RESOLUTION TO LER 92-001-00

EVALUATION OF THE EFFECTS OF USING VARIOUS
DAMPING VALUES IN THE SEISMIC ANALYSIS OF
PNPS PIPING SYSTEMS

BOSTON EDISON COMPANY
OCTOBER 1993

Response to Request for Additional Information Regarding Pilgrim Nuclear Power Station Alternative Reactor Building Response Spectra

Attachment 1 - Curve 1

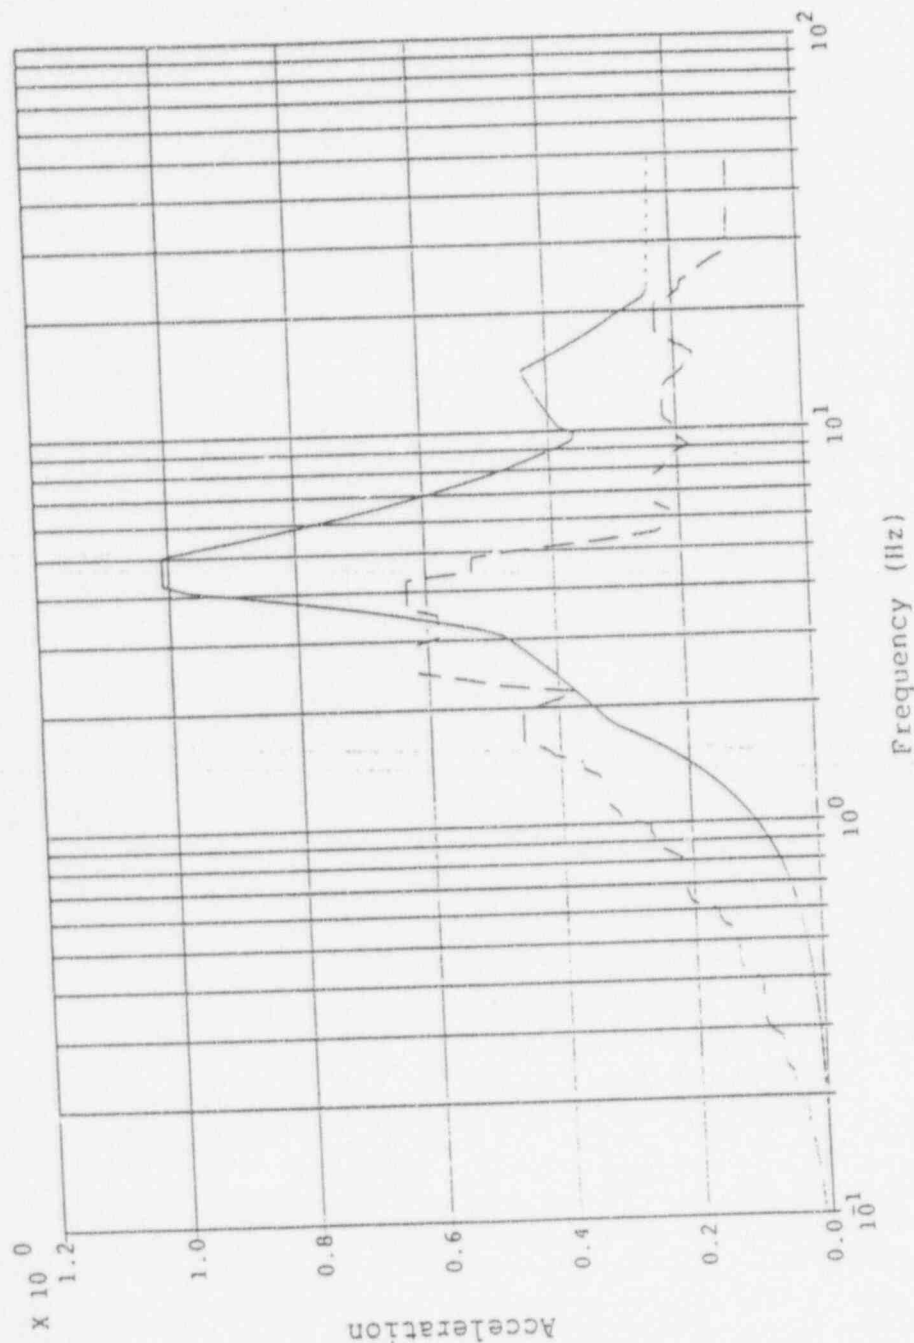
EQE Housner w/1% damping vs. BECo C-114 w/N-411 damping - (Refer to curves 1, 2 and 3 in attachment A) The EQE Housner curve w/1% damping is generally enveloped by the BECo C-114 curve w/N-411 damping in the horizontal directions. At the lowest elevations, there is a small area below 4 Hz where this is not the case. This is not considered significant since most seismically designed piping systems have a fundamental frequency in the range of 5 to 12 Hz. (Piping systems do not respond to seismic inputs which are below their natural frequency and so this small area noted above is not expected to affect any PNPS piping). For the BECo C-114 curves, there were no specific vertical input spectra. Vertical spectra for any location in the plant was taken to be 2/3 of the horizontal ground input, which amounts to about 0.25g input. The EQE Housner curves contain a specific vertical curve for each reactor building node. These new vertical curves have peaks ranging from around .4g to 1.0g. The effect of this minor increase in vertical seismic input is expected to be offset by the more significant reductions seen in the horizontal curves.

At the lowest elevations of the Reactor Bldg. structure, there is a small area where the EQE Housner curve is not enveloped by the C-114 curve. This occurs at about 4 Hz or less. In this region the peaks of the two curves are the same; however, the peak of EQE Housner curve is shifted slightly to the left. The effect is not very extensive and is not considered to have any significant effect since the large majority of seismically designed piping systems have a fundamental frequency greater than 4 Hz. Piping does not respond to frequency inputs which are less than its natural frequency. (See note 2 below).

BECO: Pilgrim Reactor Building, Elevation 23.0'
 Comparison of RG 1.60 Spectra vs. C114 Design Spectrum

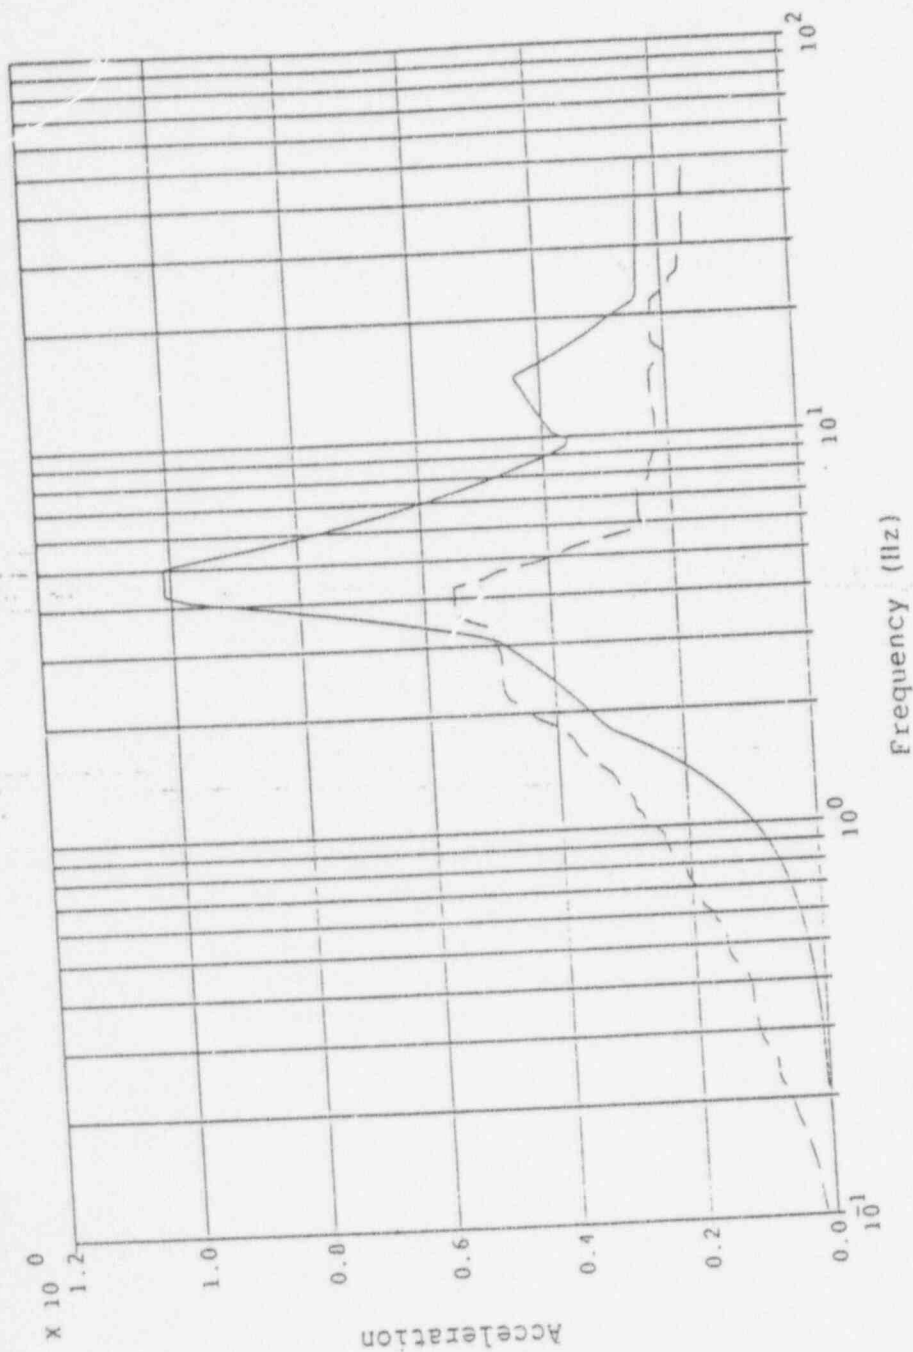
EQE R. G. 1.60 w/N-411 damping vs. BECo C-114 w/N-411 damping - (Refer to curves 4, 5, and 6 in attachment A) The EQE R.G. 1.60 curve w/N-411 damping is generally enveloped by the BECo C-114 curve w/N-411 damping in the horizontal directions. At the lowest elevations, there is a small area below 4 Hz where this is not the case. This is not considered significant since most seismically designed piping systems have a fundamental frequency in the range of 5 to 12 Hz. (Piping systems do not respond to seismic inputs which are below their natural frequency and so this small area noted above is not expected to affect any PNPS piping). For the BECo C-114 curves, there were no specific vertical input spectra. Vertical spectra for any location in the plant was taken to be 2/3 of the horizontal ground input, which amounts to about 0.25g input. The EQE R.G. 1.60 curves contain a specific vertical curve for each reactor building node. These new vertical curves have peaks ranging from around .4g to 1.0g. The effect of this minor increase in vertical seismic input is expected to be offset by the more significant reductions seen in the horizontal curves.

At the lower elevations of the Reactor Bldg., there is a small area where the EQE R.G. 1.60 curve is not enveloped by the BECo C-114 curve. This occurs at about 4 Hz or less. The peaks of the two curves are the same, the peak of EQE R.G. 1.60 curve is shifted slightly to the left. The effect is not very extensive and is not considered to be significant since the large majority of seismically designed piping systems have a fundamental frequency greater than 5 Hz. Piping does not respond to frequency inputs which are less than its natural frequency. See note 2 below.

SSE Pipe Stress Level Comparisons

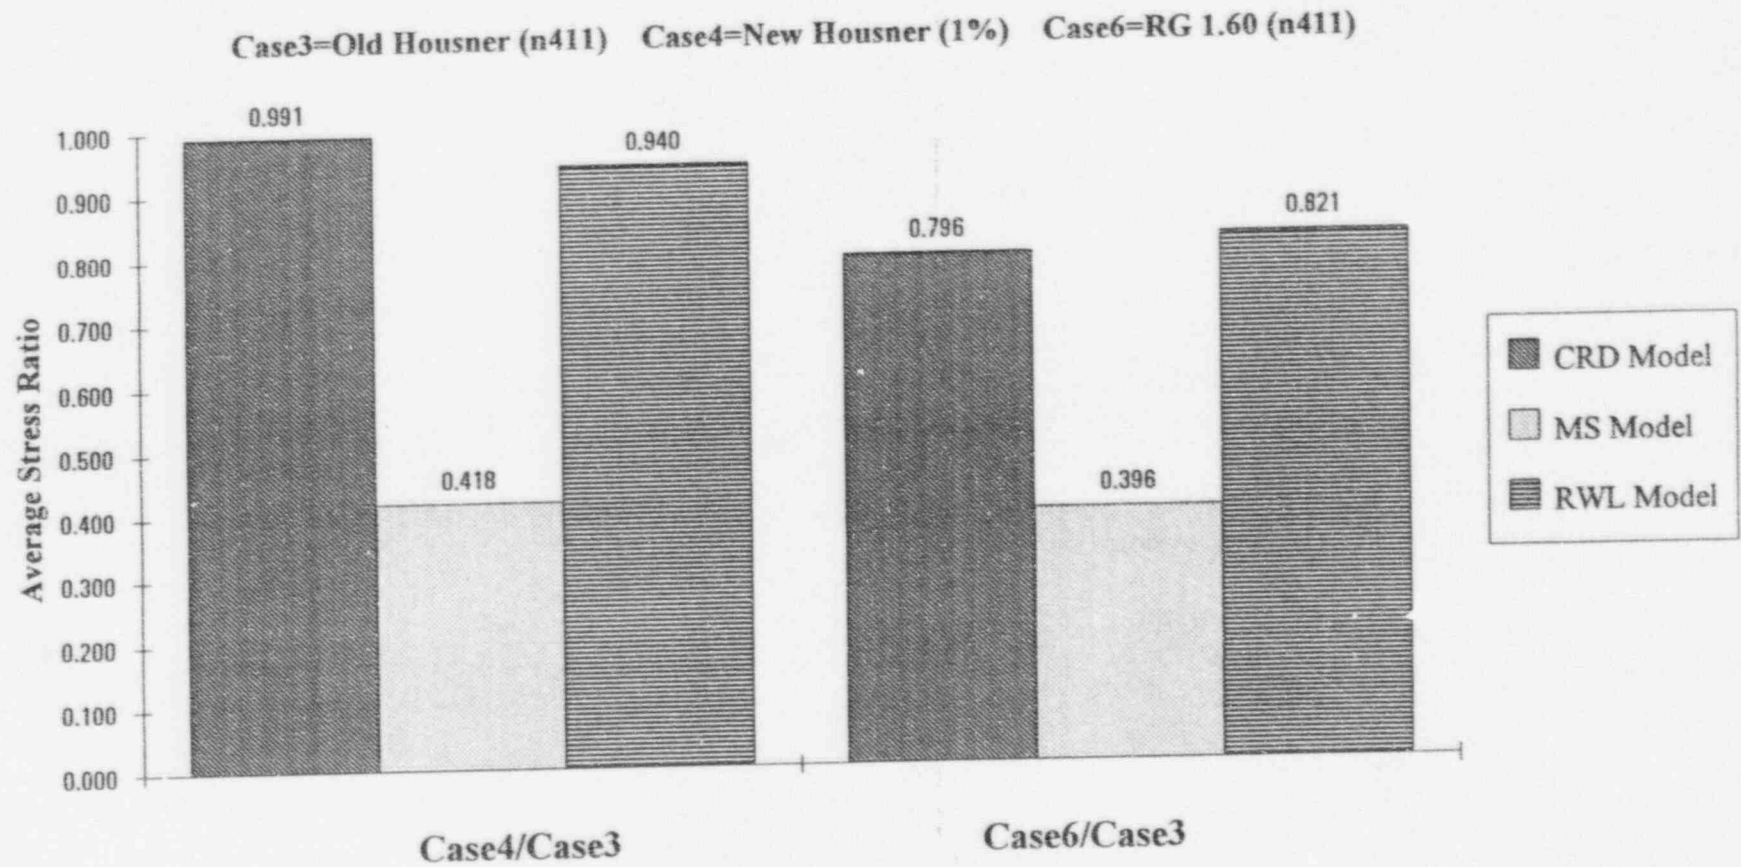
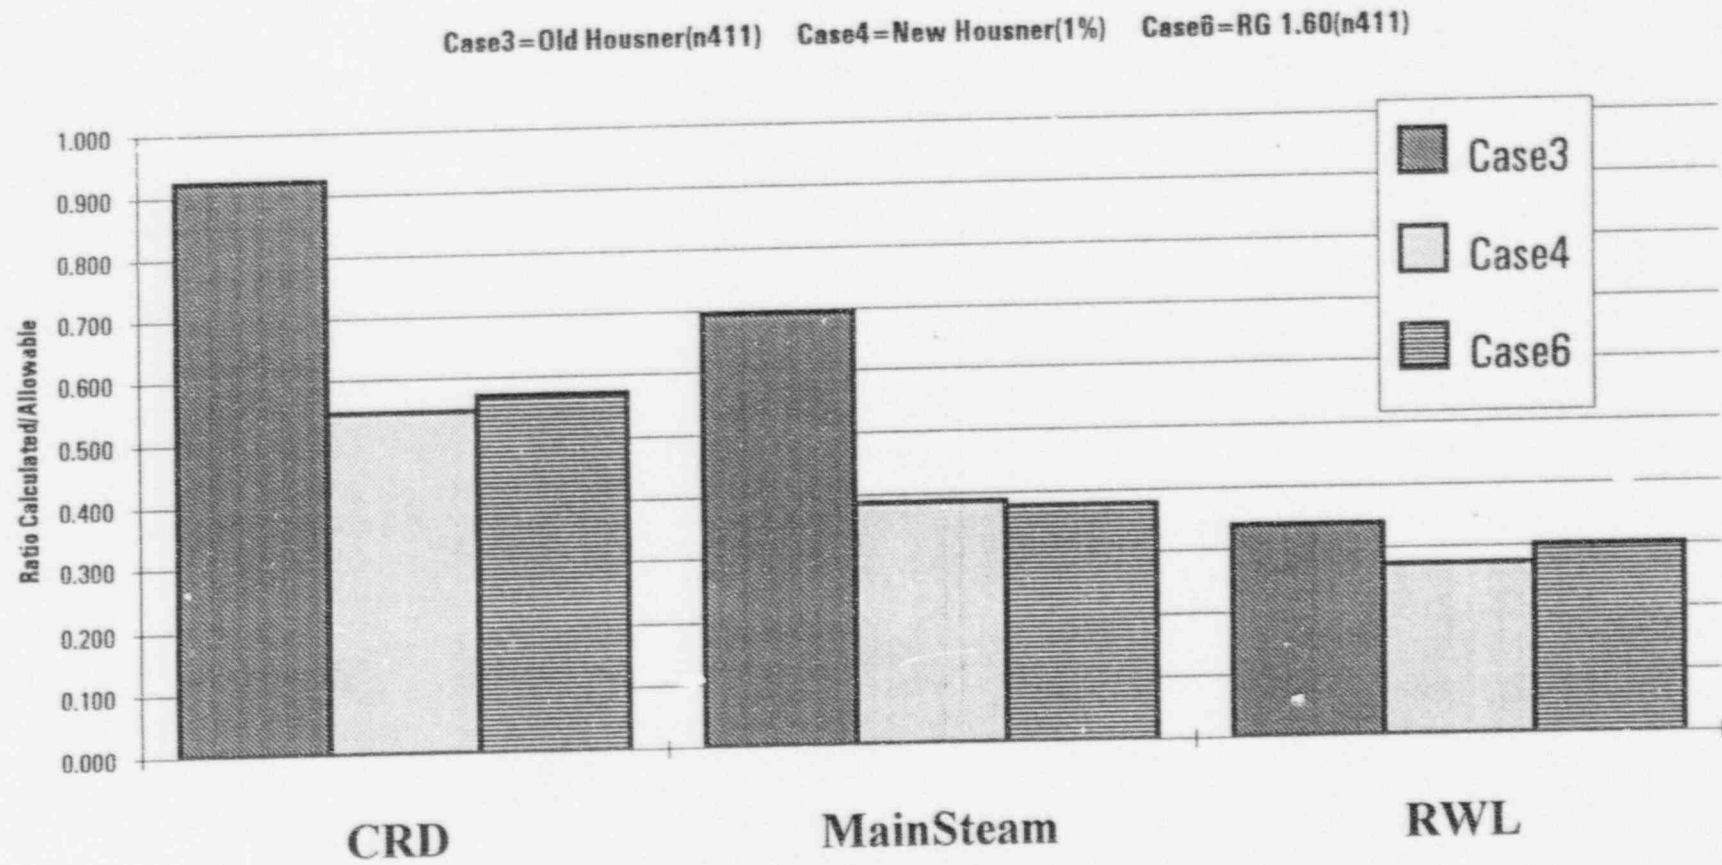
- Case4 vs. Case3 ratio of stress:
SSE Average = 0.342
OBE Average = 0.418

- Case4 vs. Case3 ratio of stress:
SSE Average = 0.653
OBE Average = 0.940

SSE Average	= 0.563
OBE Average	= 0.991
- Ratio of Max Calculated to Code Allowable

FAULTED Max Calculated Stresses vs. Code Allowable

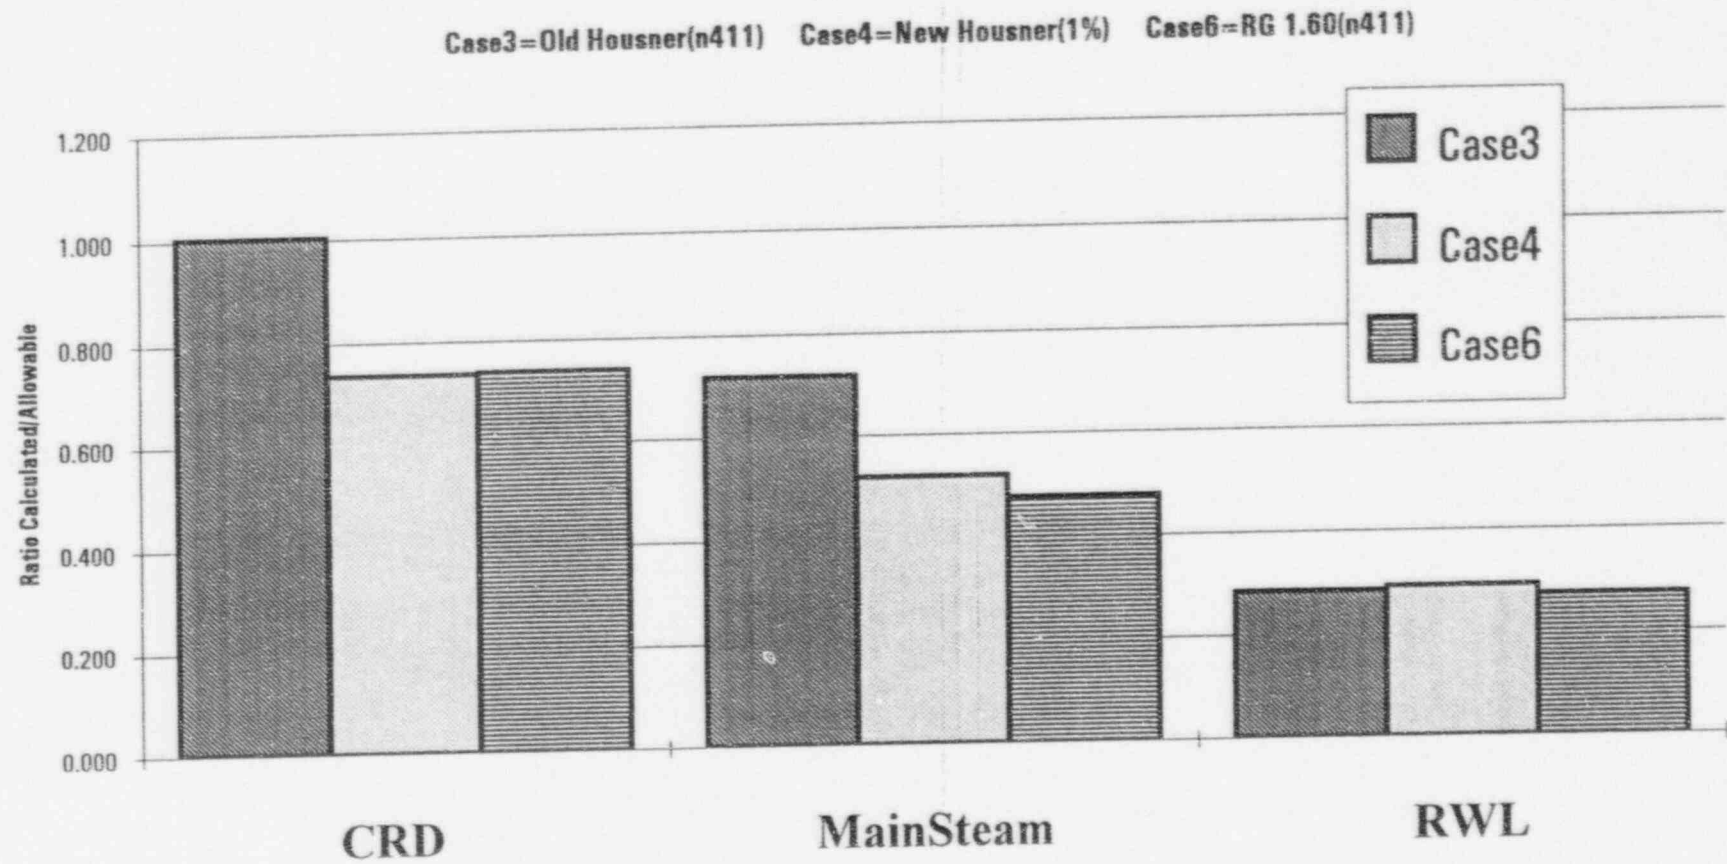
Case3:	Upset = 0.72	Faulted = 0.70
Case4:	Upset = 0.52	Faulted = 0.38
Case6:	Upset = 0.48	Faulted = 0.37

Case3:	Upset = 0.28	Faulted = 0.34
Case4:	Upset = 0.29	Faulted = 0.27
Case6:	Upset = 0.27	Faulted = 0.30

Case3:	Upset = 1.00	Faulted = 0.92
Case4:	Upset = 0.75	Faulted = 0.55
Case6:	Upset = 0.75	Faulted = 0.57

SSE Pipe Support Equipment Nozzle Loads

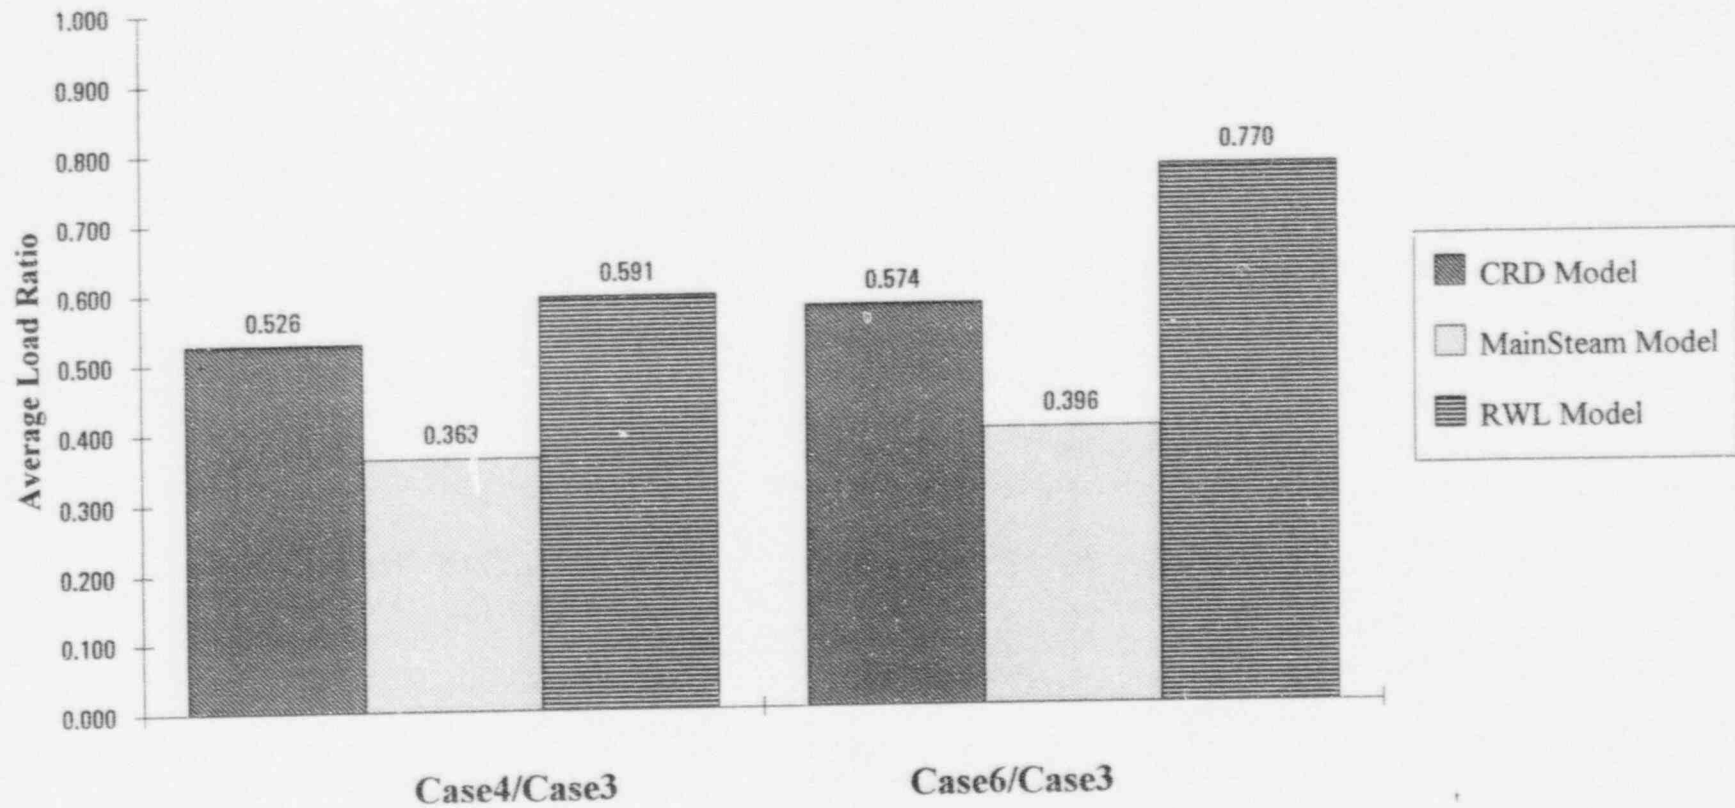
- Cases4, Case5, and Case6 were all very similar and always produced lower loads than Case3.
- Case4 vs. Case3 ratio of loads:
SSE Average = 0.363
OBE Average = 0.489

- Same tendencies as stresses.
- Case4 vs. Case3 ratio of loads:
SSE Average = 0.591
OBE Average = 0.855

SSE Average	= 0.526
OBE Average	= 0.574
